Addendum No. 2  
May 16, 2023

JSD Jefferson E.S.

## **ADDENDUM NO.2**

**PROJECT**      **Jefferson Elementary School Addition and Remodel**  
Jerome, Idaho

2 Plumbing New Work Plan - Area 'E'  
Scale: 1/8" = 1'-0"

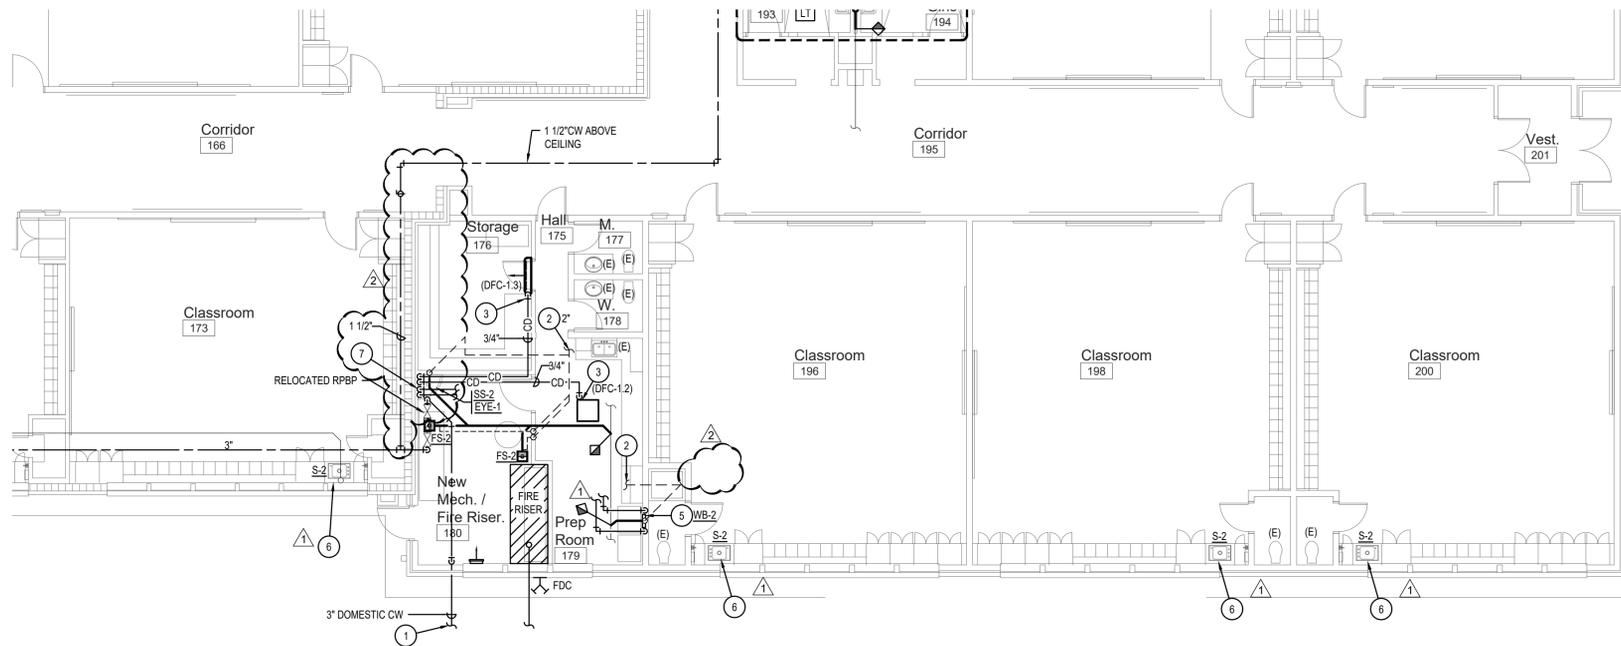
#### Sheet P-2.4 Plumbing New Work Plan – Area E

1. Deleted Shr-1 and keynote 4.
2. Revised 1 ½" water piping connection to be down stream of backflow device.
3. Added Keynote 7 for Service sink and Eyewash cw and hw connections.
